RE: GEOTECHNICAL REVIEW OF MACRAES LOM DESIGN 2015

GEOTECHNICAL REVIEW
MACRAES LOM DESIGN 2015

PSM71-194R

Plate 1: A view from the east towards FRIM Stage 1 (grey) showing the proposed (pink) and existing (blue) stoping.

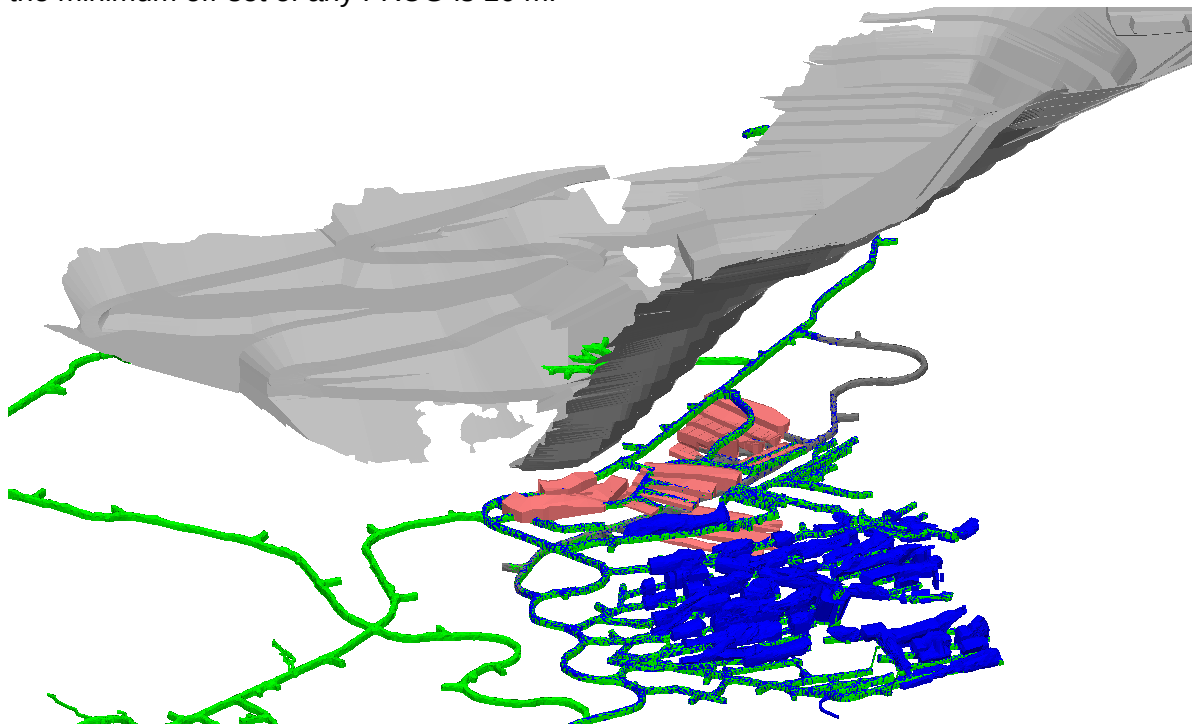
The minimum off-set of the proposed stoping from FRIM Stage 1 pit slopes is 40 m, and the minimum off-set of any FRUG is 10 m.

A recent report assessed the impact of FRUG workings on the proposed Frasers 6 pit (Reference 5). Unlike Frasers 6, the FRIM Stage 1 pit does not cut into FRUG workings. However, some interaction is still expected specifically:

- Slope stability affected by proposed stoping
- Working above broken or caved rock mass.

There are no specific recommendations if the FRIM Stage 1 pit is mined before the FRUG stopes. If that is not the case, then OceanaGold will need to develop safe working procedures to mine above voids and broken or caved rock mass. Suggestions regarding probing etc. are provided in Reference 5.

Figure 3

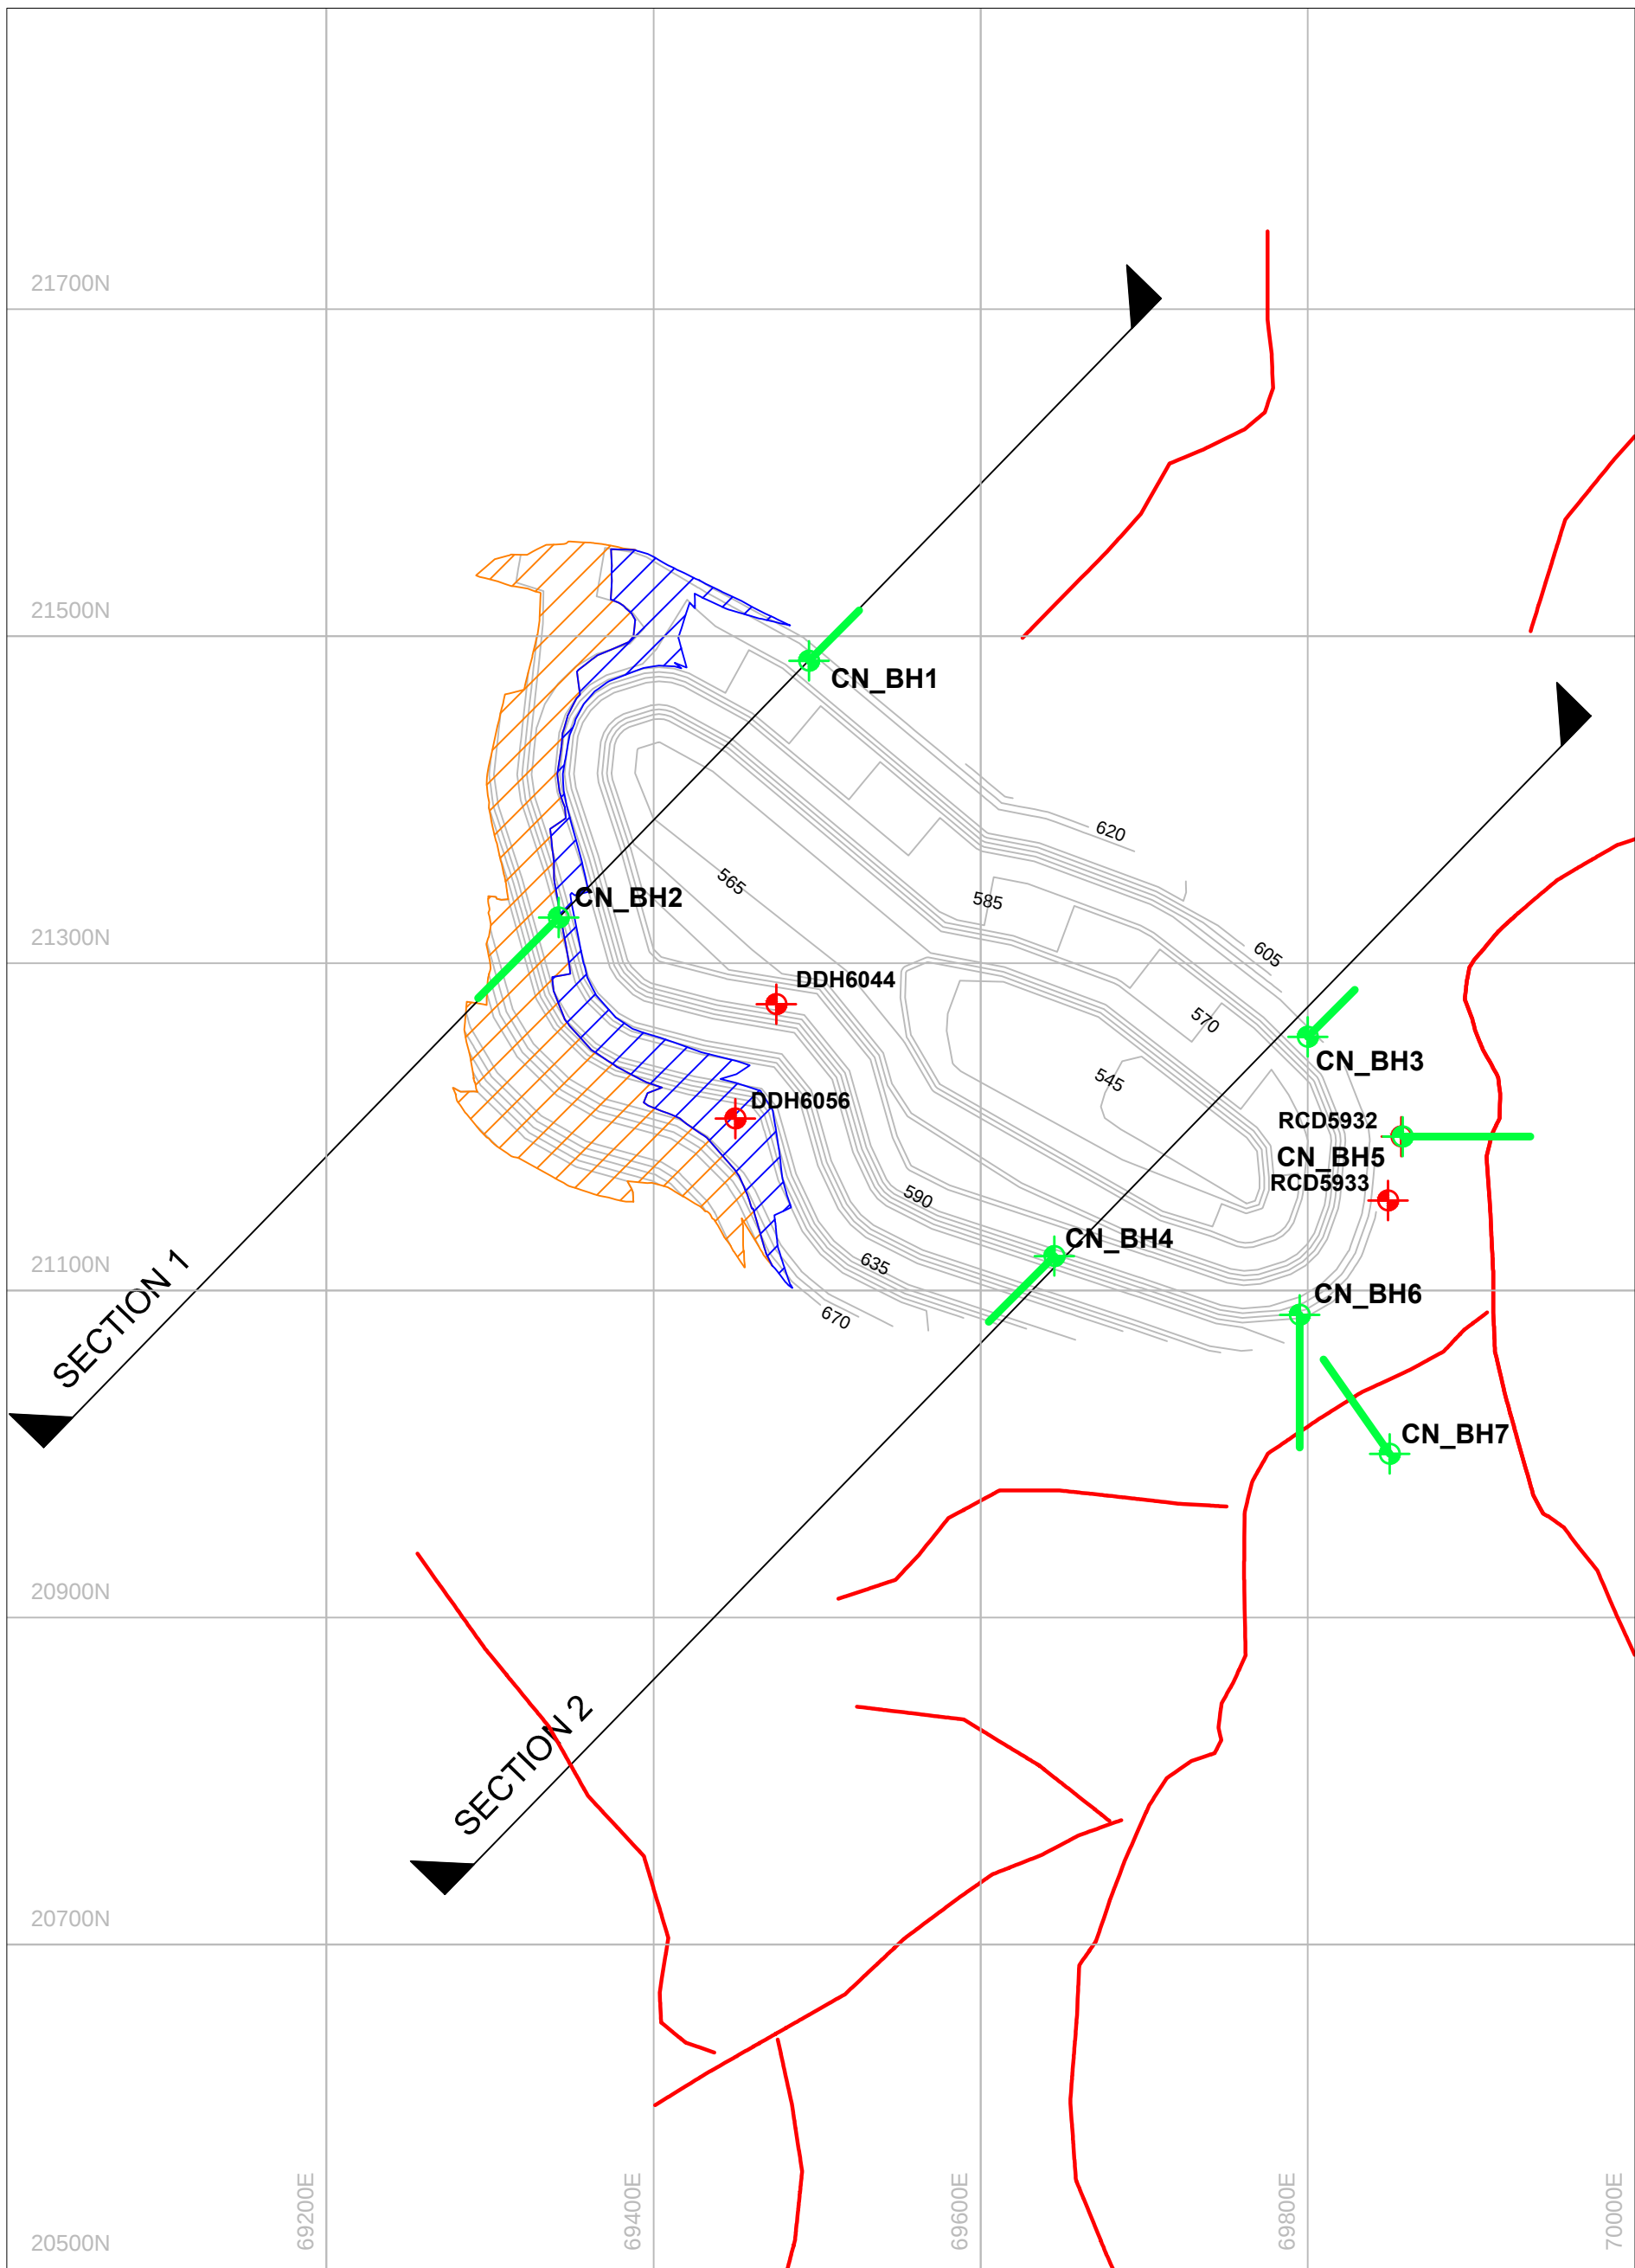
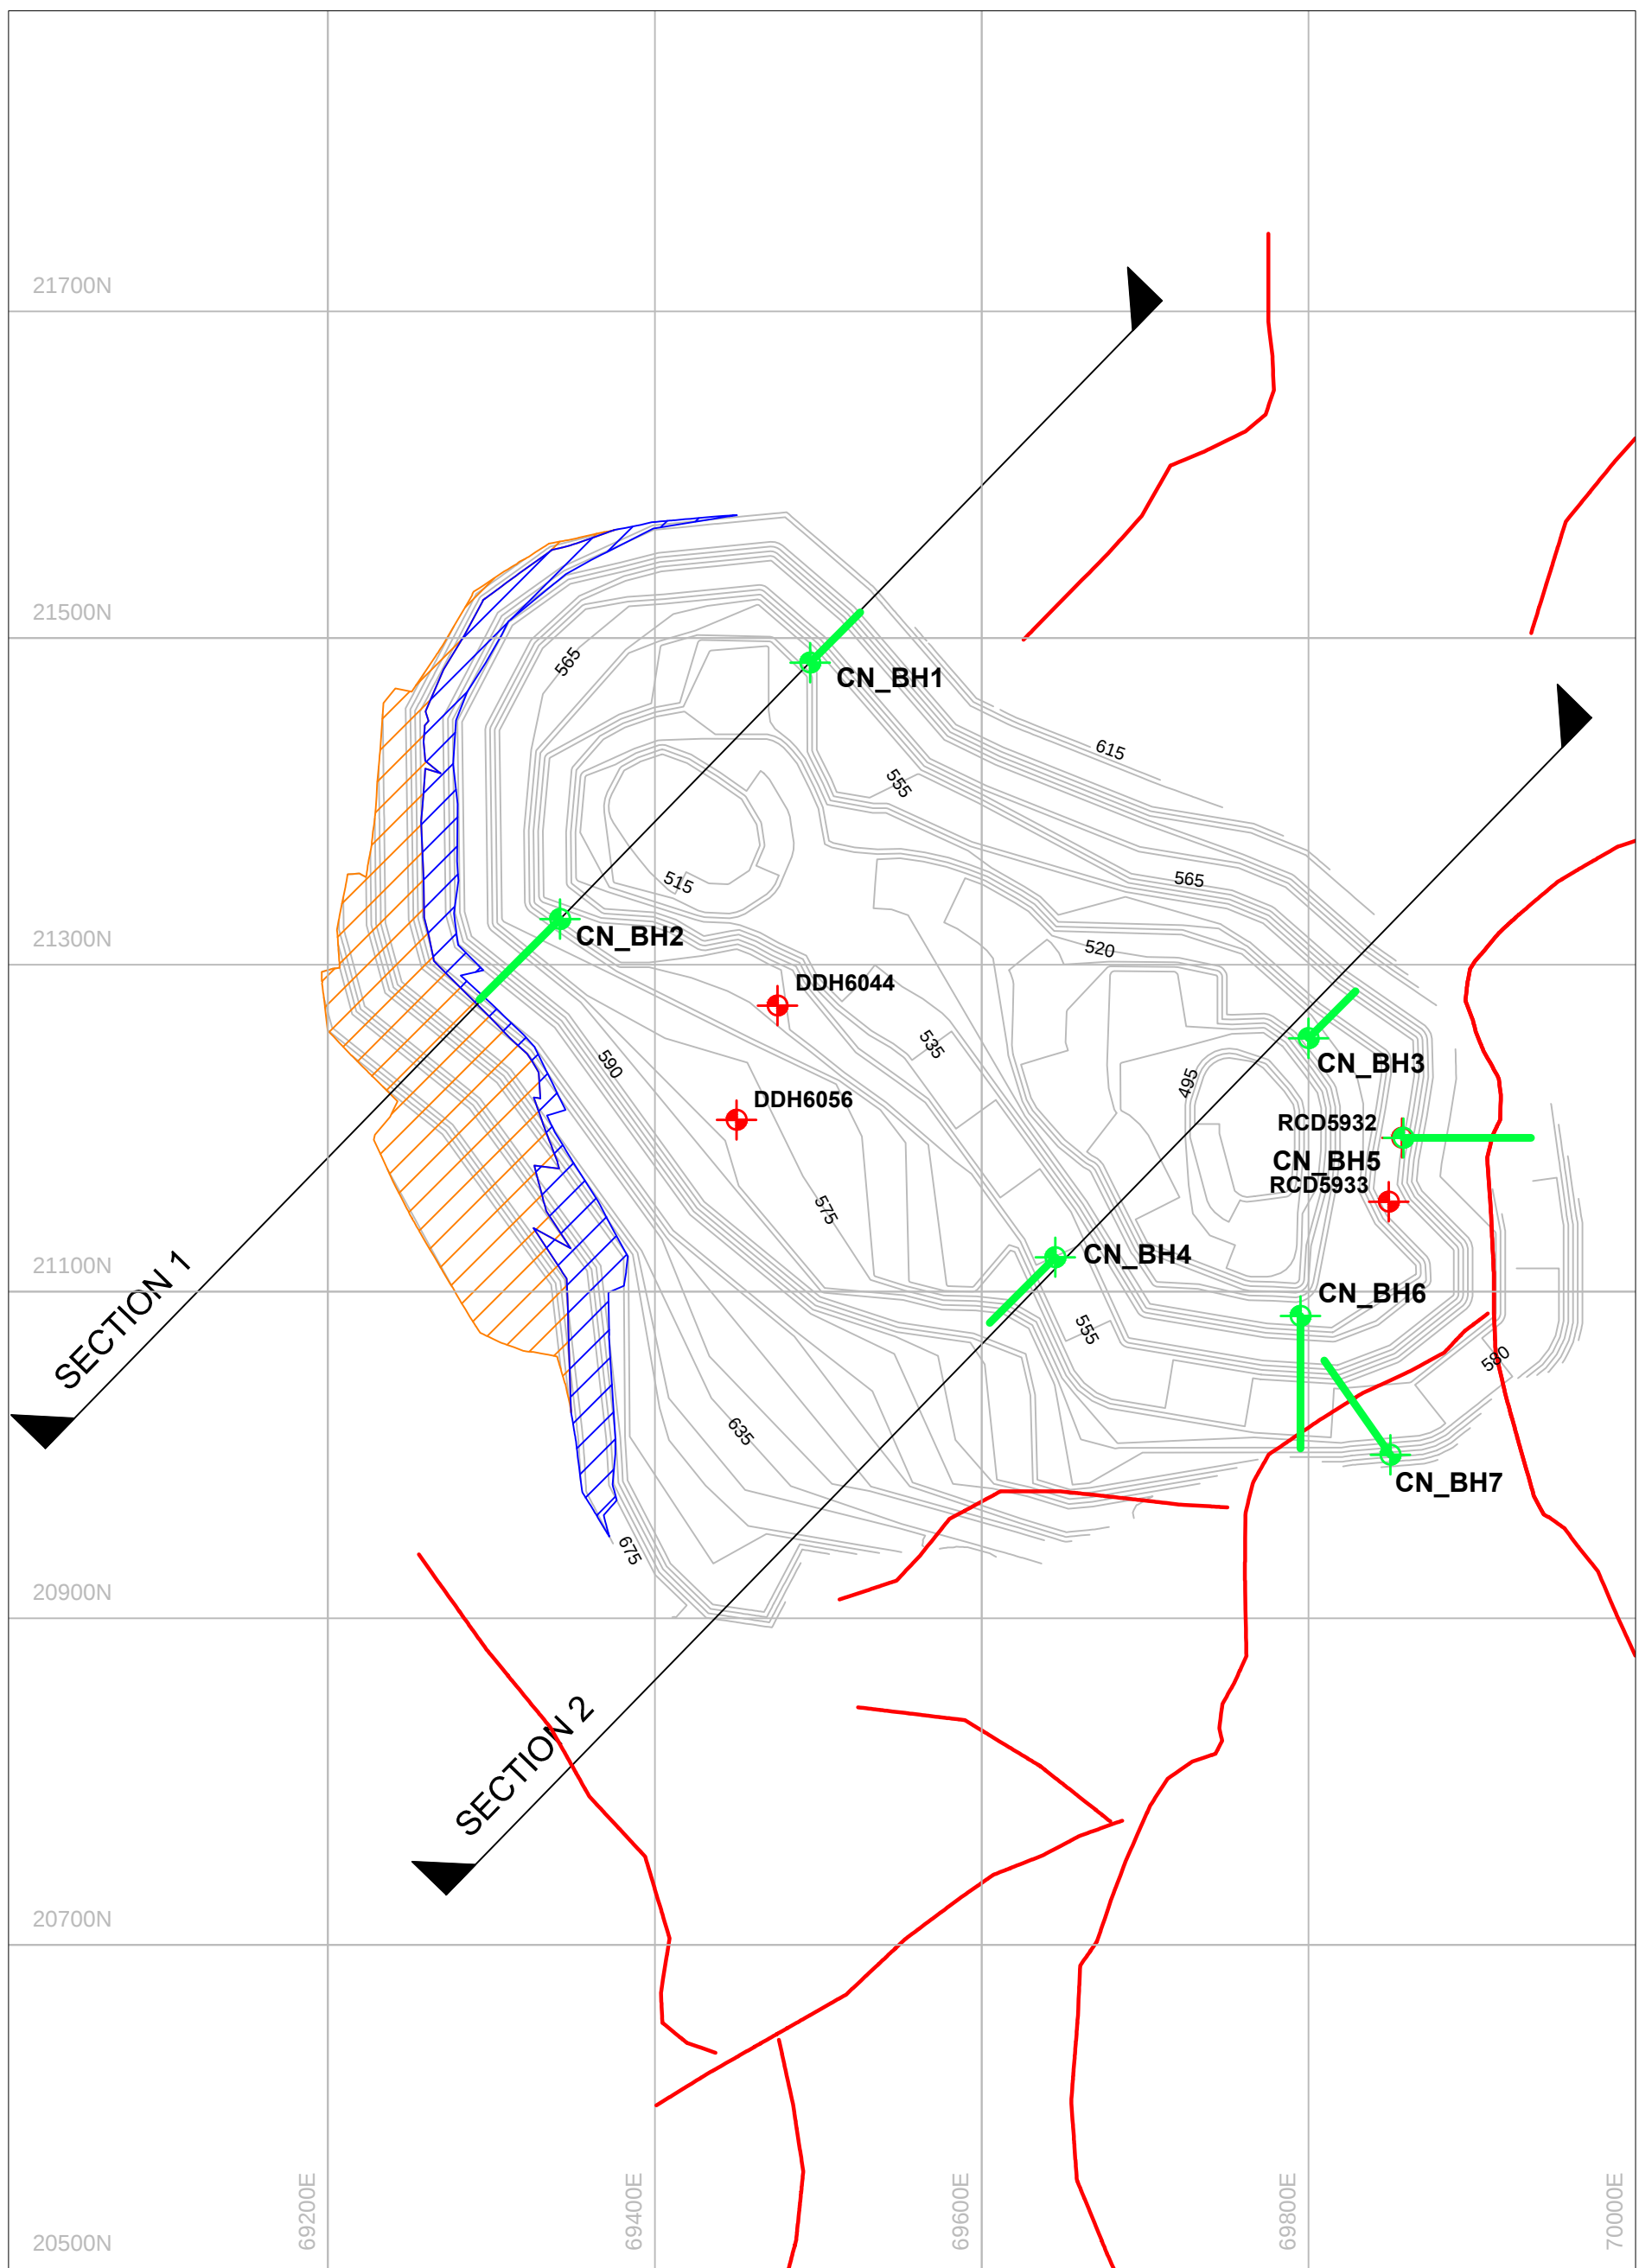
Given the geotechnical uncertainty of the Coronation North area, the base risk is generally higher than for the other pits. However, the pit design produces relatively shallow walls so the risk is generally considered to be moderate. The exception is the south-eastern end of the pit which abuts a steep gorge. A confluence of major lineaments also is inferred to affect this end of the proposed pit.

The geotechnical model for Coronation North needs to be developed to reduce the uncertainty of conditions.

- Seven boreholes have been planned to target the proposed pit walls, in particular the south-eastern end of the pit (Reference 3).
- Structural interpretation of major structures needs to be carried out.
